MISSISSIPPI RIVER-GULF OUTLET, LOUISIANA

GENERAL DESIGN MEMORANDUM NO. 2
SUPPLEMENT NO. 3
BAYOU LA LOUIRE RESERVATION

February 1968

SUBJECT: Mississippi River-Gulf Outlet, La., General Design Memorandum
No. 2, Supplement No. 3, Bayou La Loutre Reservation

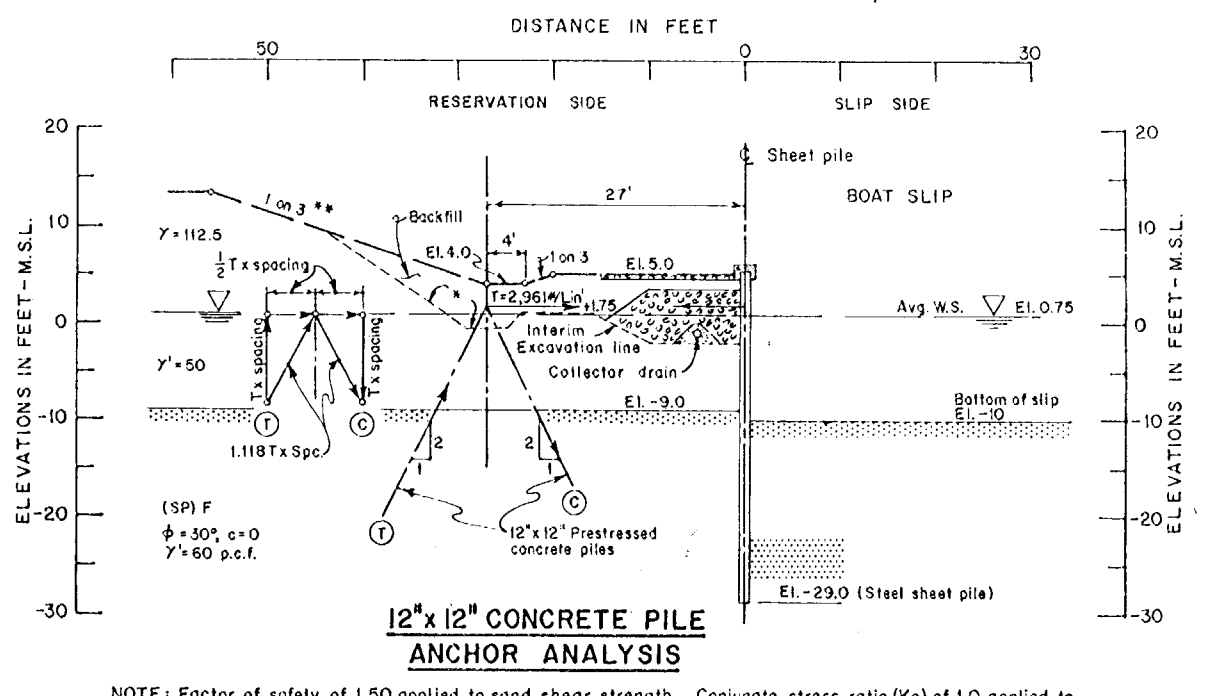
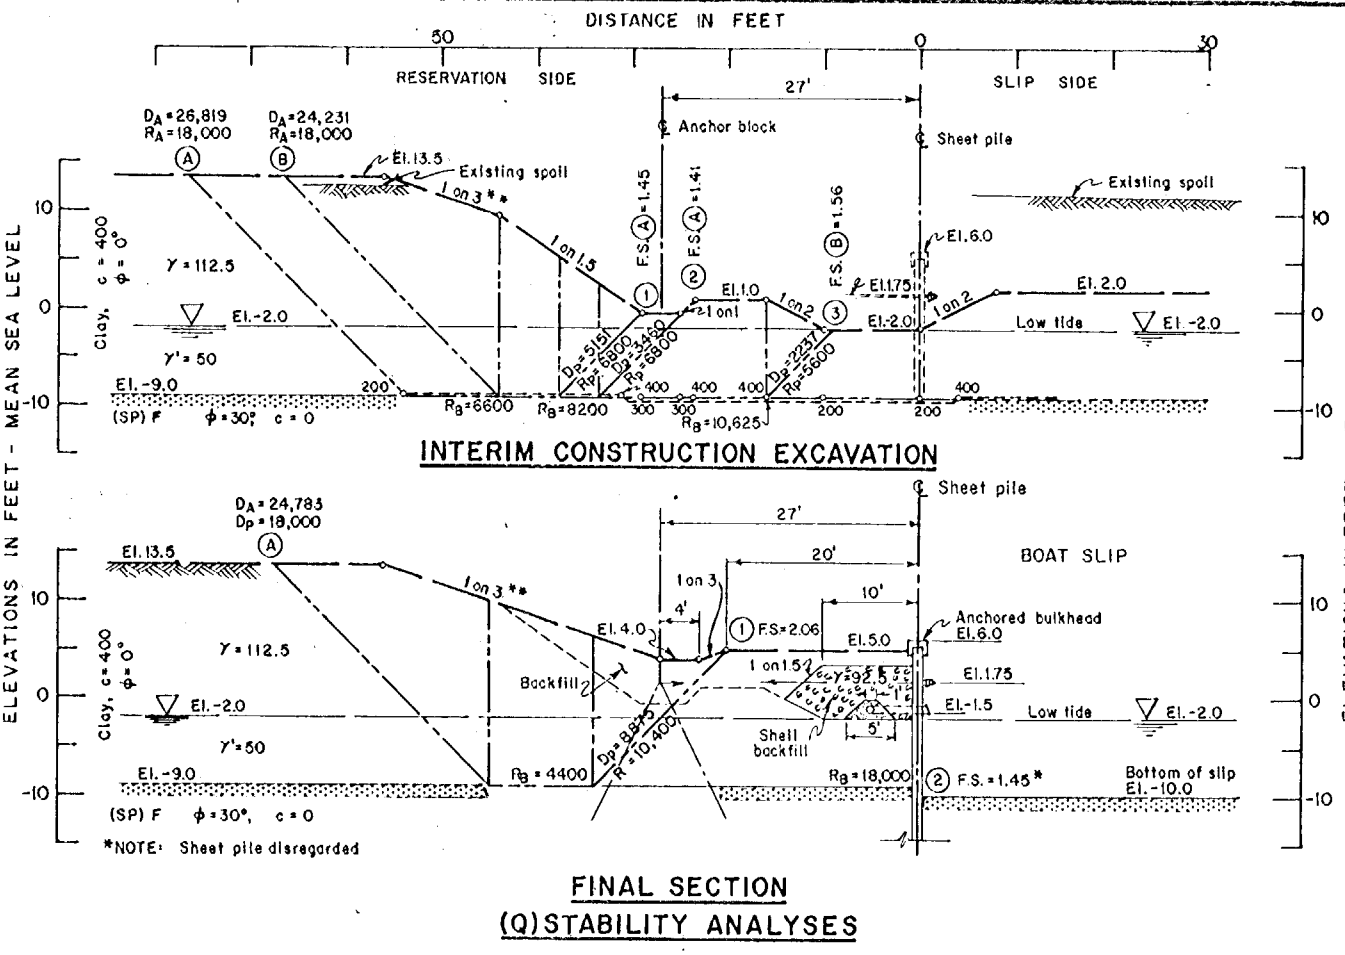
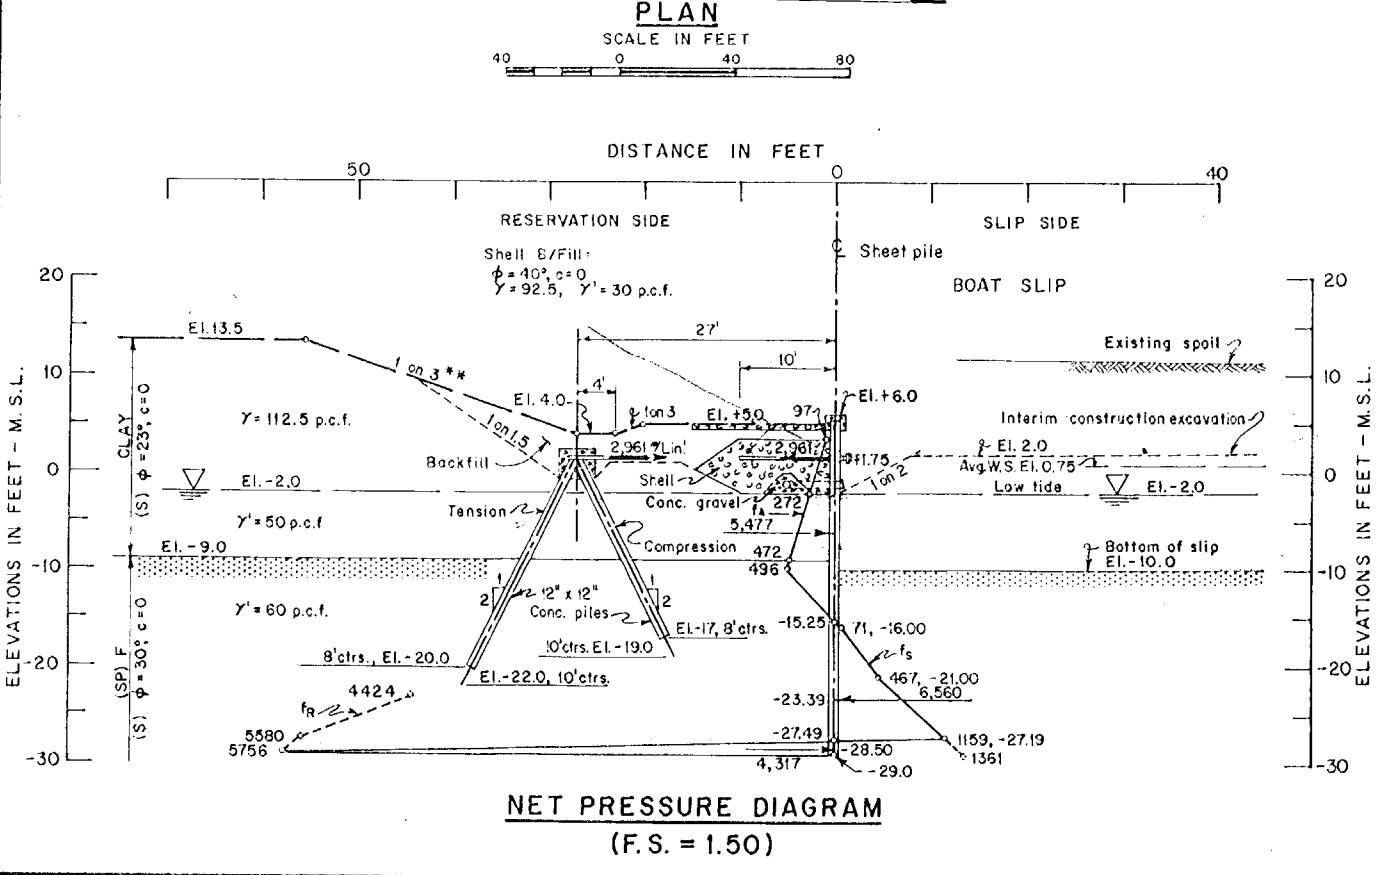
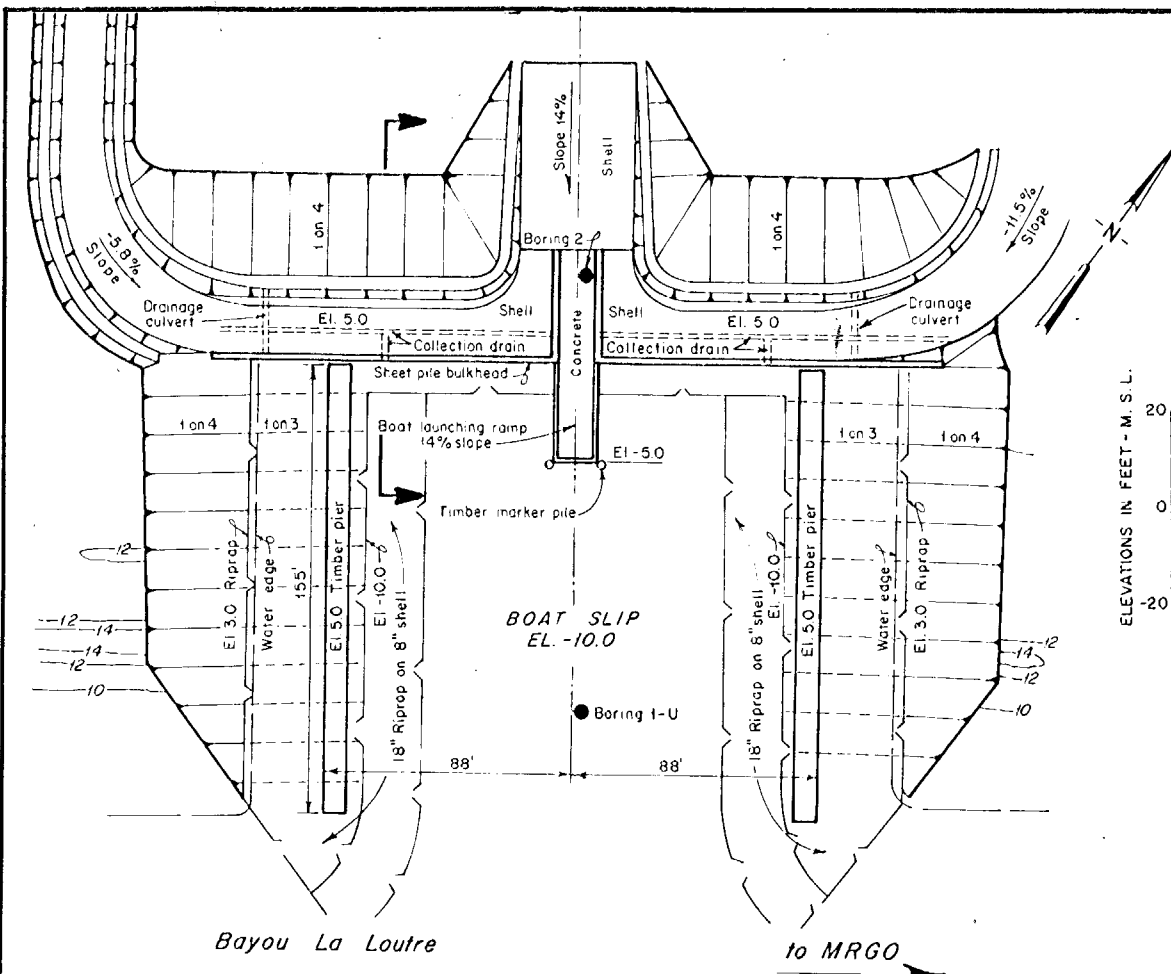
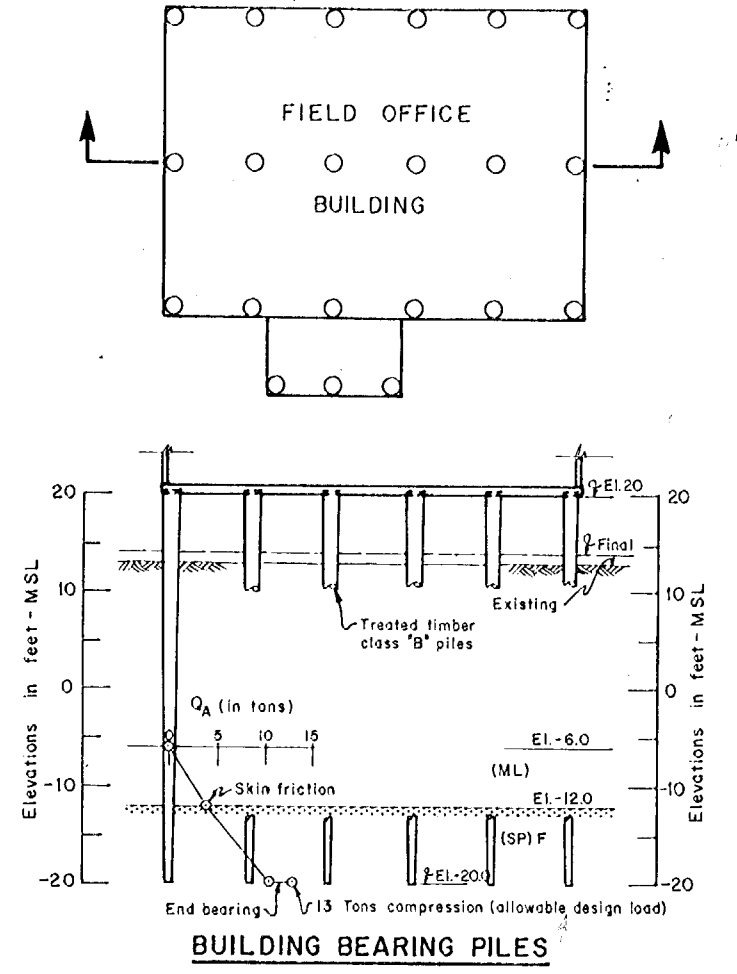
4. Plate III-1. To help prevent damage to the flap valve, the outlets of the collector drains should be located in the recessed portion of the sheet pile as indicated in red.

4. Plate III-1. Concur.
